August 22, 2017
Medway Planning and Economic Development Board
155 Village Street
Medway, MA 02053

Public Hearing Continuation
Paul Revere Estates Definitive Subdivision Plan
33 Main Street

PAUL REVERE ESTATES
DEFINITIVE SUBDIVISION
COVER SHEET
PLAN OF LAND IN
MEDWAY, MA

STORMWATER BASIN - PROFILE

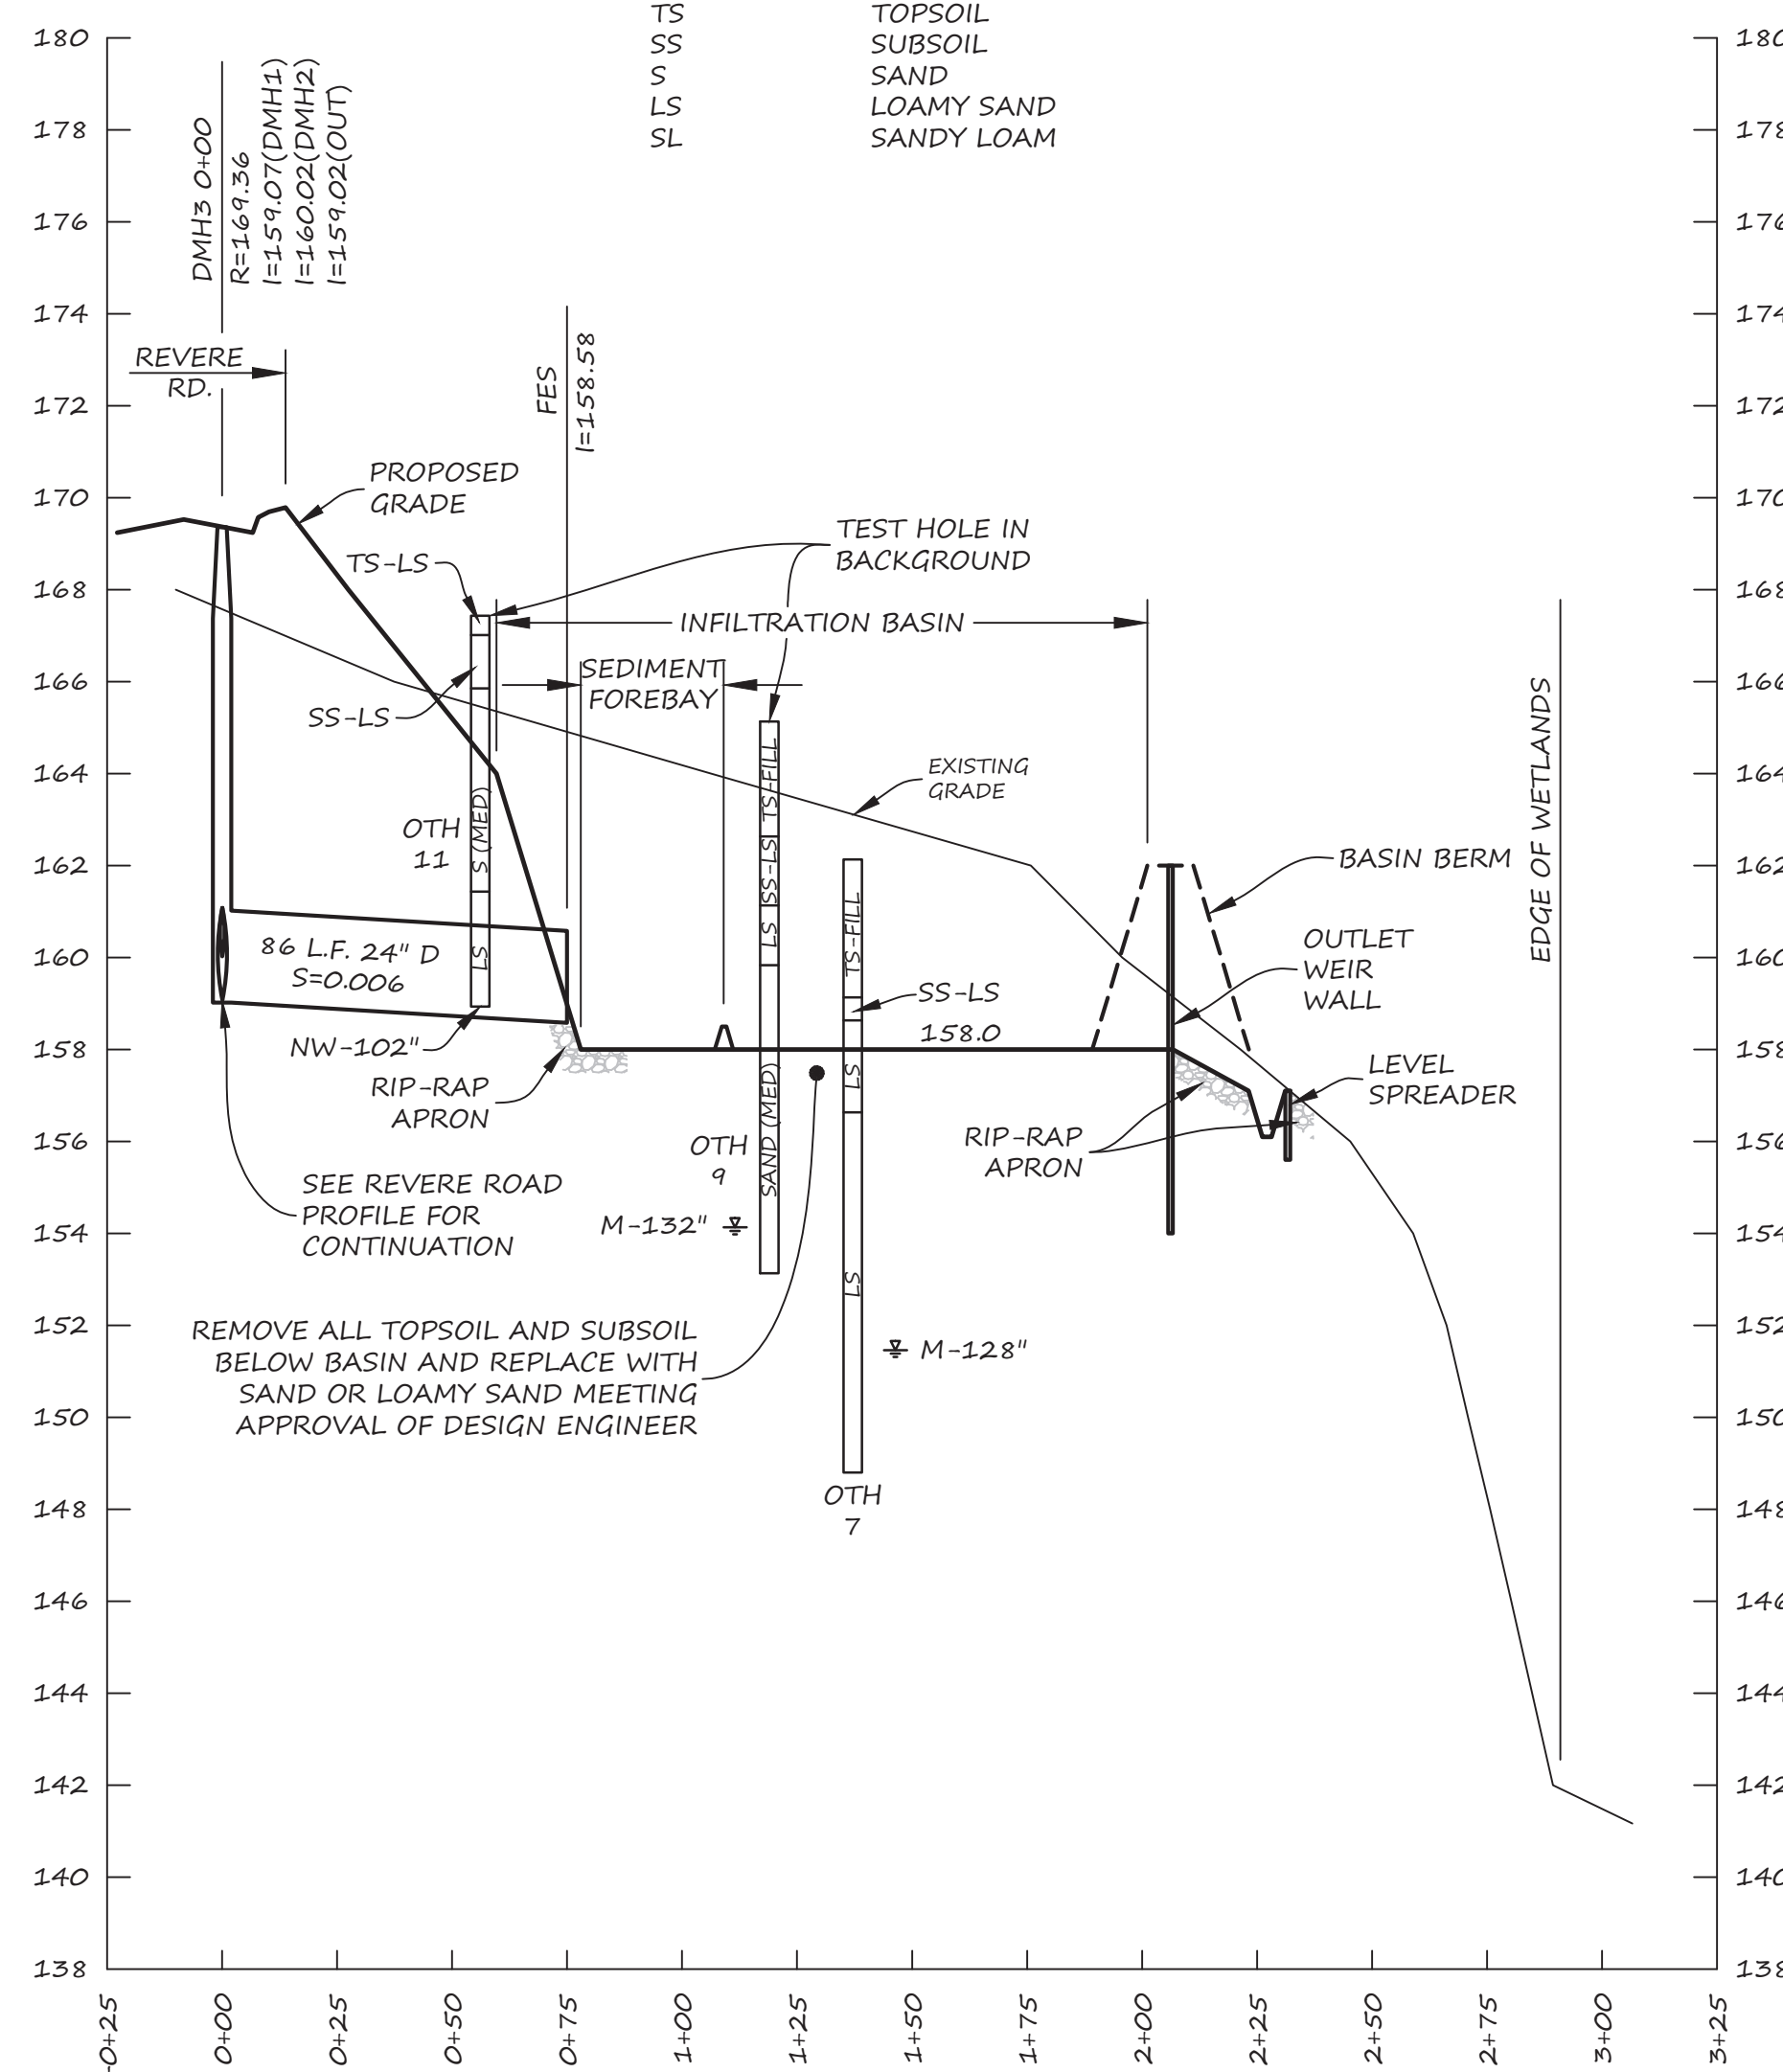
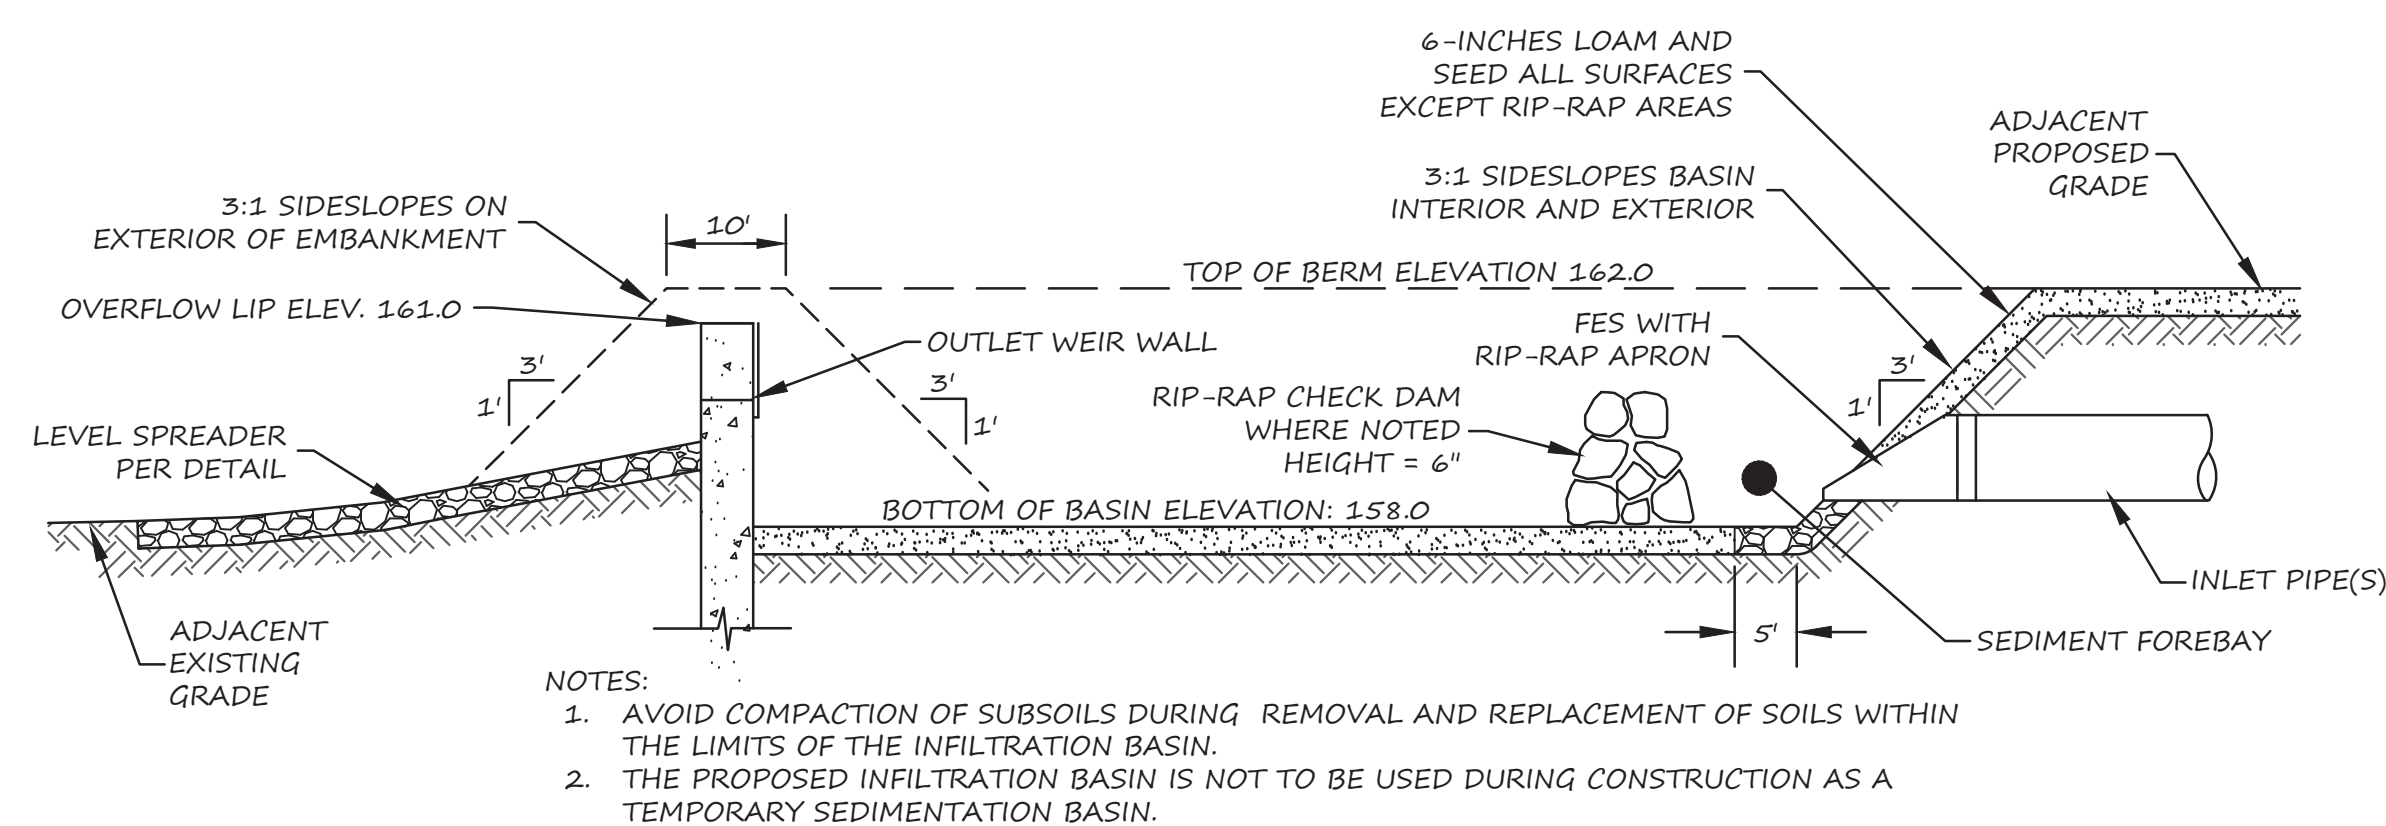
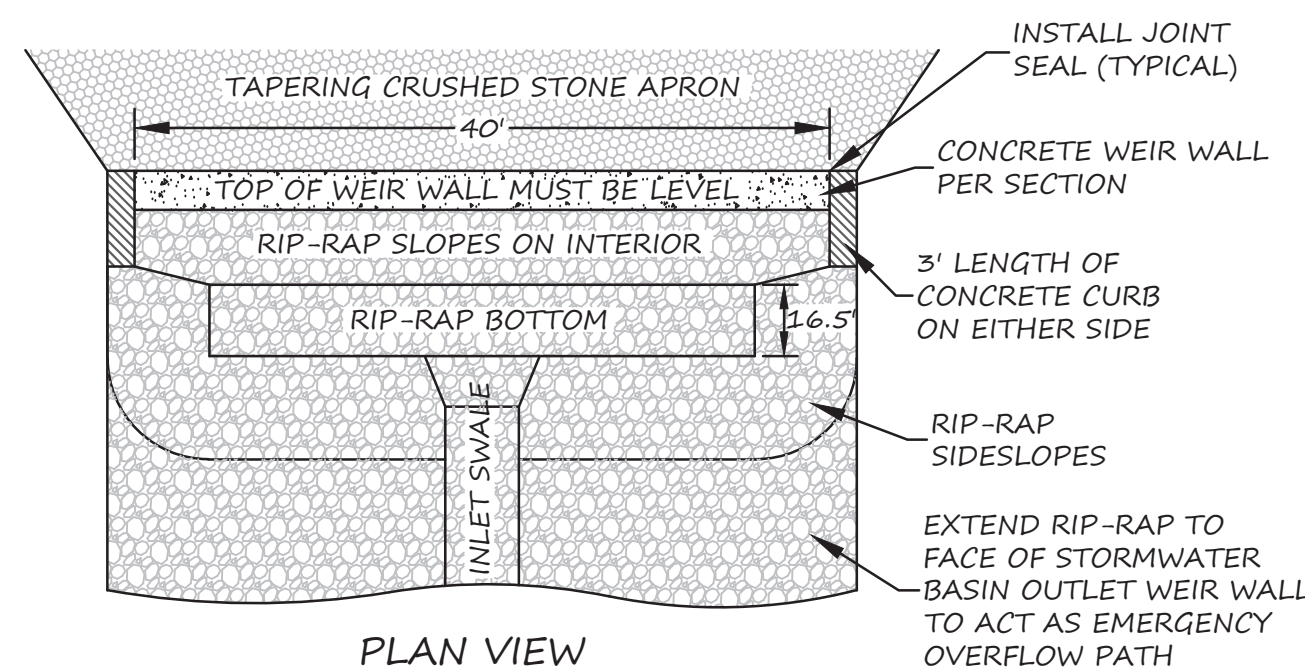
14. *Comment: The applicant shall provide a note on the "Stormwater Basin – Profile" detail on Sheet 7 to prevent compaction of subsoils during removal and replacement of soils within the limits of the proposed infiltration basin. Furthermore, proposed basin should not be used during construction as a temporary sedimentation basin to prevent choking of voids in subsoils by sediment.*

- TT 8/14/17 Update: This item has been addressed to our satisfaction.
- 14) The applicant shall provide a note on the “Stormwater Basin – Profile” detail on Sheet 7 to prevent compaction of subsoils during removal and replacement of soils within the limits of the proposed infiltration basin. Furthermore, proposed basin should not be used during construction as a temporary sedimentation basin to prevent choking of voids in subsoils by sediment.

Response: The requested notes have been added to the "Typical Basin Cross Section" detail on sheet 8.

- *ME 8/9/17 Response: The requested notes have been added to the “Typical Basin Cross Section” detail on sheet 8.*
 - TT 8/14/17 Update: This item has been addressed to our satisfaction.

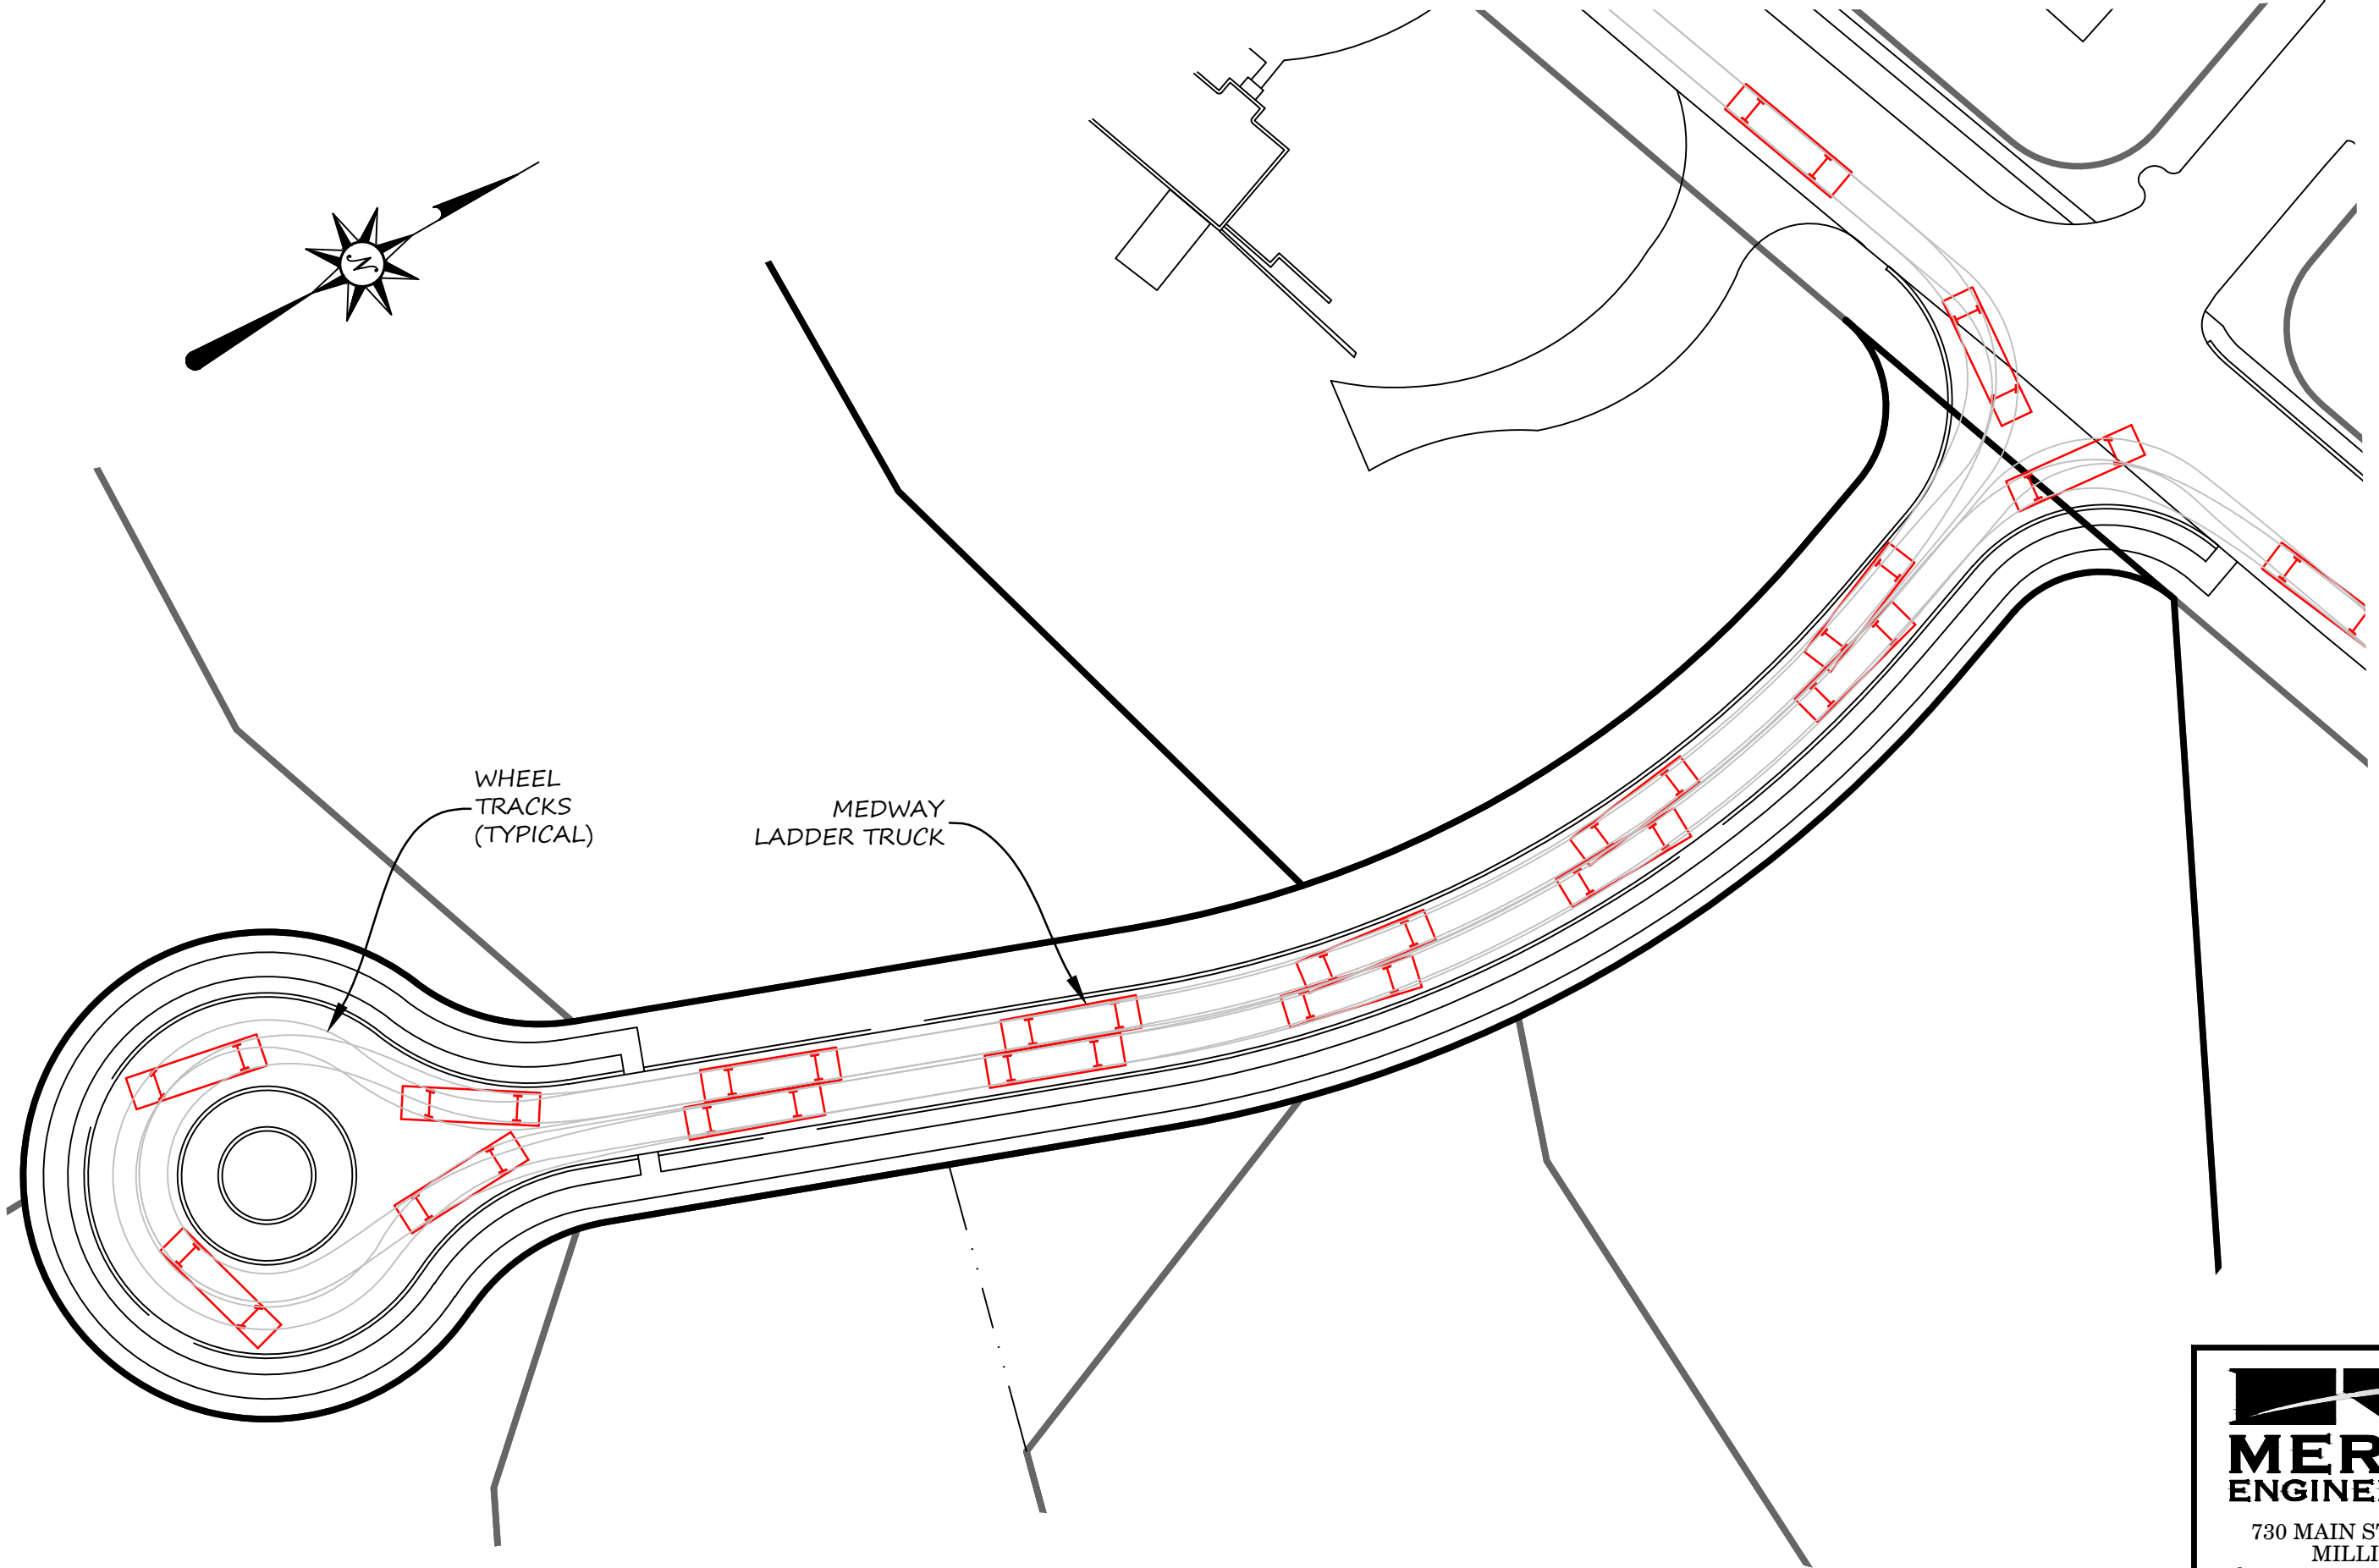
The following additional revisions have been made based on discussions with various town offices.

1. A note has been added to the layout sheet designating the owner of Lot 4 as the maintainer of the landscape island on Revere Road.
2. The note on the cover sheet regarding the fire alarm system has been removed as discussed with the board.

3. A note has been added to the layout sheet indicating that the owner of 39 Main Street may install a driveway to the new road on the condition that all existing curb cuts along Main Street are eliminated.
